# A short explanation of the modifications made in a poor quality ECU remap

What modifications are there within a free remap file?

The ECU file compared in this document is from a Peugeot 306 HDI. This vehicle comes with a 2.0HDI common rail diesel engine capable of producing 205 Nm of torque and a peak power output of 90 BHP from the factory.

Figure 6 Comparison between standard torque limiter and bad remap

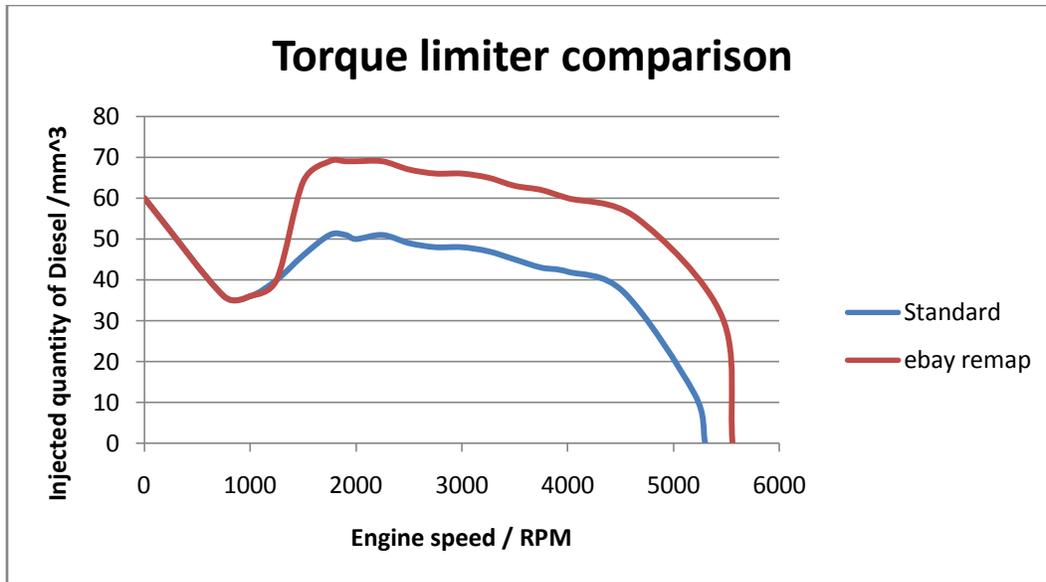
The first map we will look at is the torque limiter. This has been altered all over by the same amount (18mm<sup>3</sup>) without any concern for the points at which fuelling is increased.

Through some very crude calculations it is possible to calculate what the expected BHP output of this torque limiter would be by applying a torque conversion factor to the IQ. In the standard TL this comes out to 90 BHP at 4000 RPM. In the modified TL this comes out at 137.3 BHP at 4660 RPM. Note how the 'tuner' has tried to increase the engines maximum speed past 5300 by altering the TL axis. This is not the way to do this as there are other limiters in place. Figure 7 shows a comparison graph of the calculated BHP output for each different torque limiter.

Figure 7 BHP output comparison

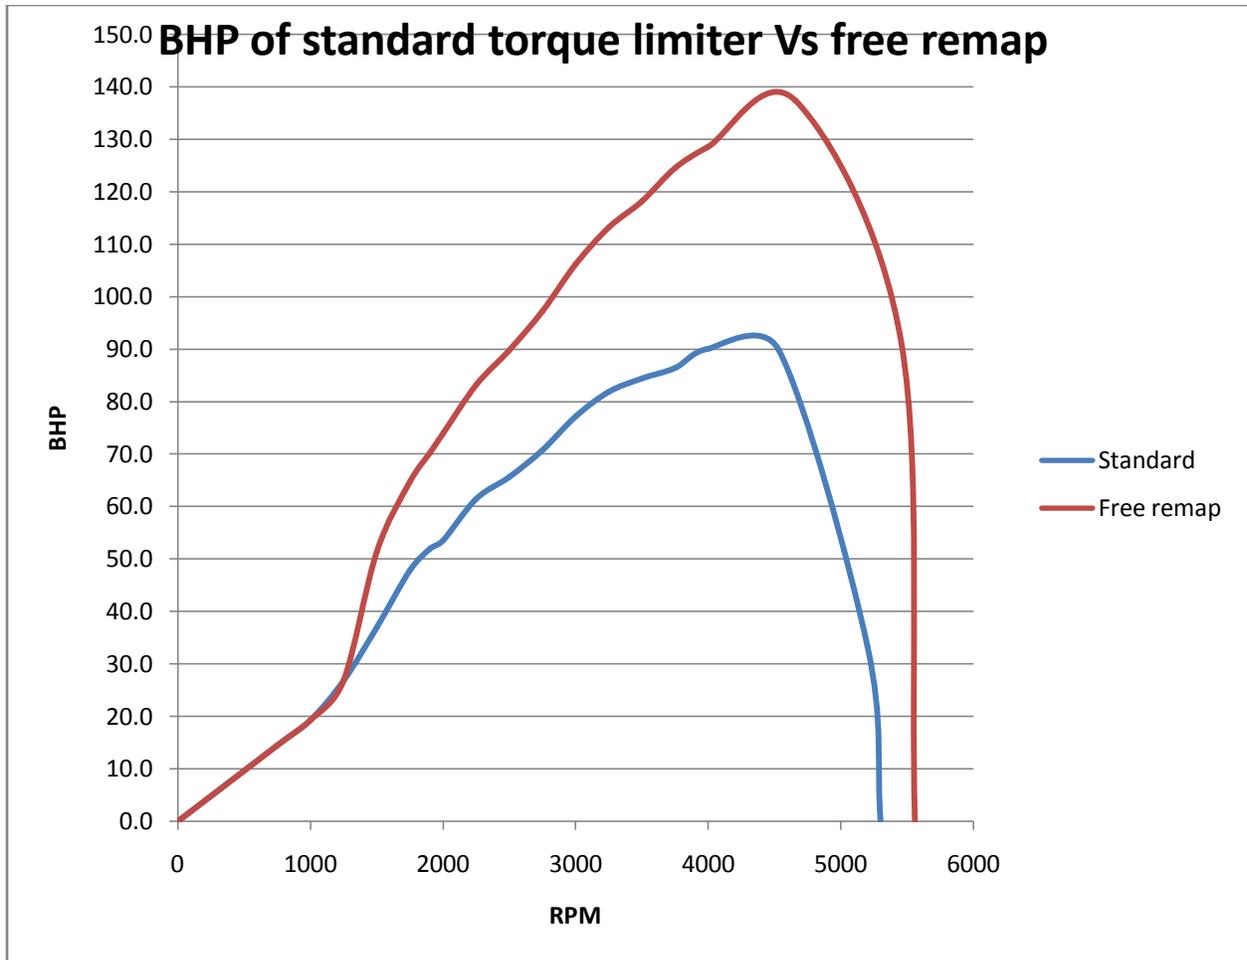
After looking at the calculated data it becomes apparent that the tuner has NO IDEA what they are doing. Requesting 140 BHPs worth of fuel on a standard stage one tune without an intercooler fitted and increased boost is a recipe for disaster. Clouds of thick black smoke would follow, and it's likely the turbine blades would incur damage due to excessive EGTs.

Figure 8 Bad remap accelerator request modification

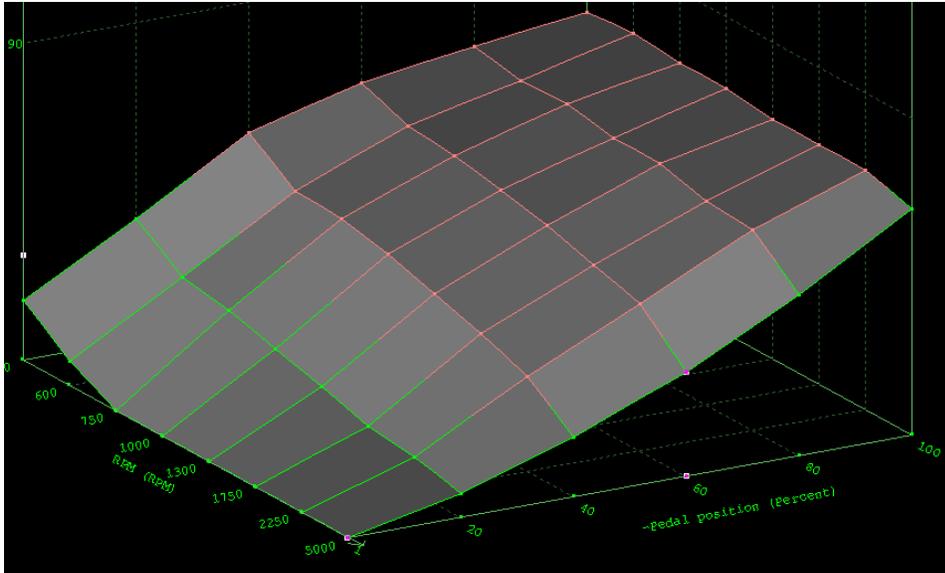
The accelerator request map was altered, but only to a maximum value of 70mm<sup>3</sup>. See Figure 8.

Figure 9 Bad remap smoke map

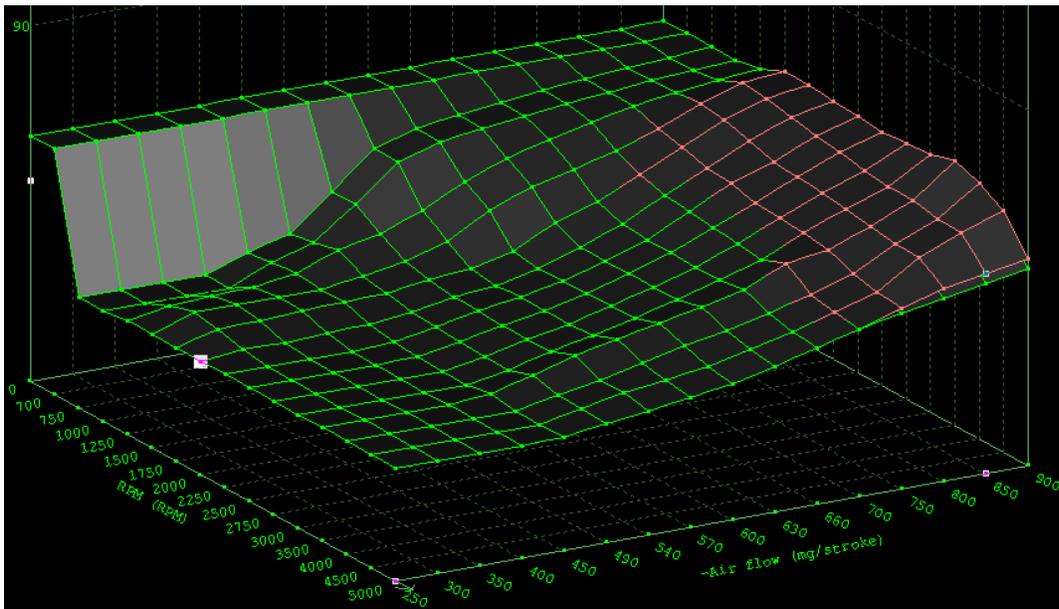
The smoke map was also altered, but again by the wrong amount. This time the smoke limiter was increased to 66-67mm<sup>3</sup>. Yet again this is lower than the quantity requested by the torque limiter which was originally the lowest setting of all the maps in the standard ECU file.

Figure 10 IQ limits from bad remap

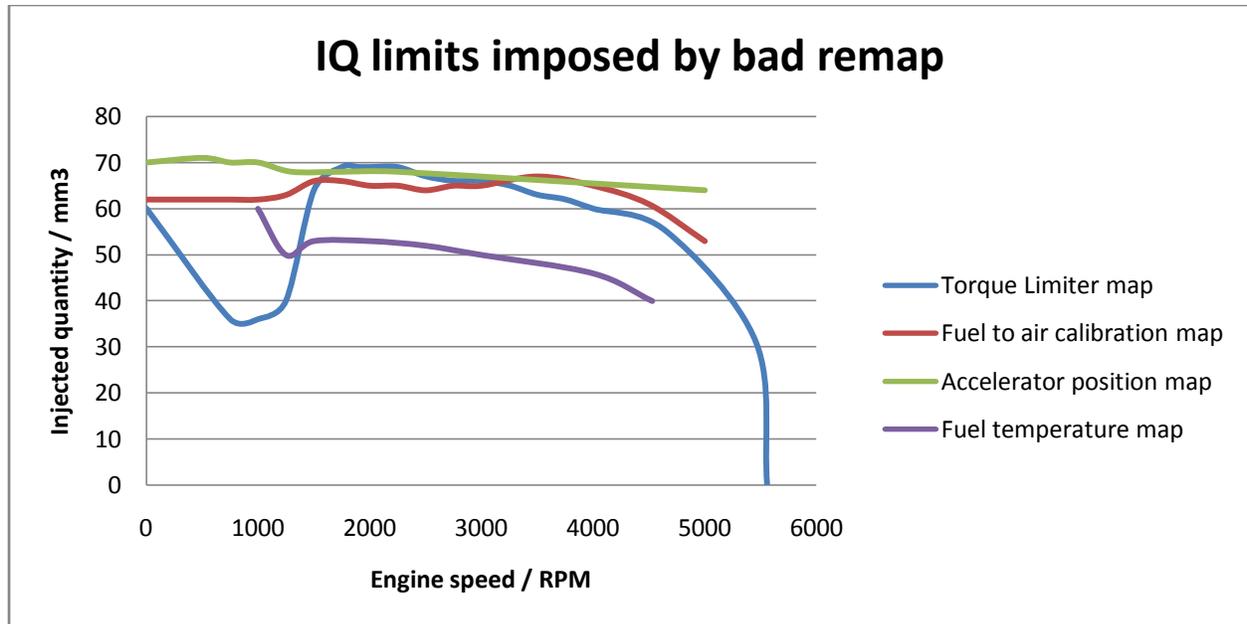
If a new comparison is carried out between the maps, (see Figure 10) the fuel temperature limiter is now controlling the amount of diesel being injected in to the engine rather than the torque limiter as before. Note how the limits are no longer well separated for smooth running conditions as in the standard ECU file shown in Figure 5.

Figure 11 Fuel pressure map. Axes of RPM (right) and requested fuel quantity (left)

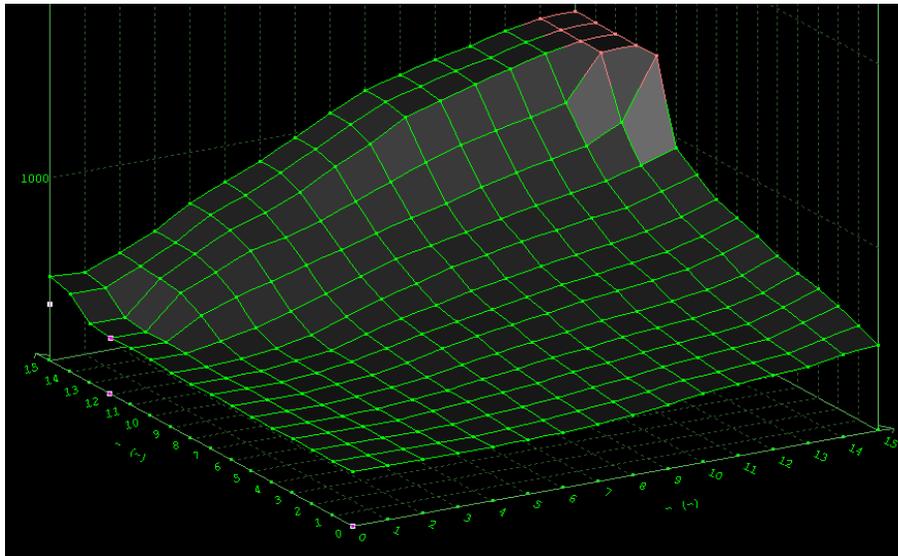
On first glance of the fuel pressure map it would seem that the fuel pressure has been increased to 1389 Bar (1350 bar is standard on the HDI engines). This would be ok, only if the associated rail pressure limiters had been altered. Well, surprise surprise, the fuel pressure limiters have all been missed, so the fuel pressure is really 1350 Bar maximum. (please note, I forgot to include the axes in Figure 11. These should be IQ and RPM)

Figure 12 BAD remap, alterations to injector calibration map

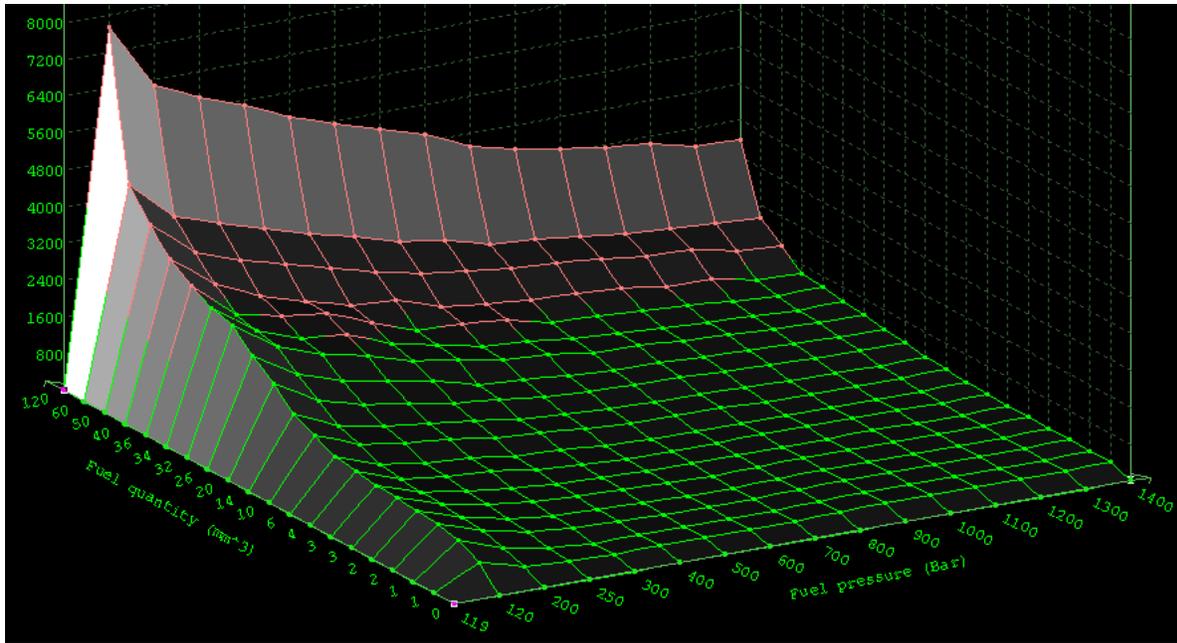
Ok, back to calculating the fuel flowing through the injectors. We now know that: Peak BHP settings are at 4000 RPM in this remap, at this point an IQ of 46mm<sup>3</sup> is requested from the fuel temperature limiter, and the fuel pressure is 1350 Bar. If we look at the injector calibration map (see Figure 12) we can see that the injector opening time has been changed from 783.6 to 861.6 micro seconds at this point (This required a bit of interpolation between the four points given, see the table below for further details)

Note how the calibration map has been changed in the top left corner by a large amount. To an unskilled tuner this part of the map would look like the 'biggest' part, so they would probably think it right to change it. If you look at the axes you will see this part is actually at just 119 bar of fuel pressure. This kind of pressure would only be reached during cranking. Completely useless for a performance remap!
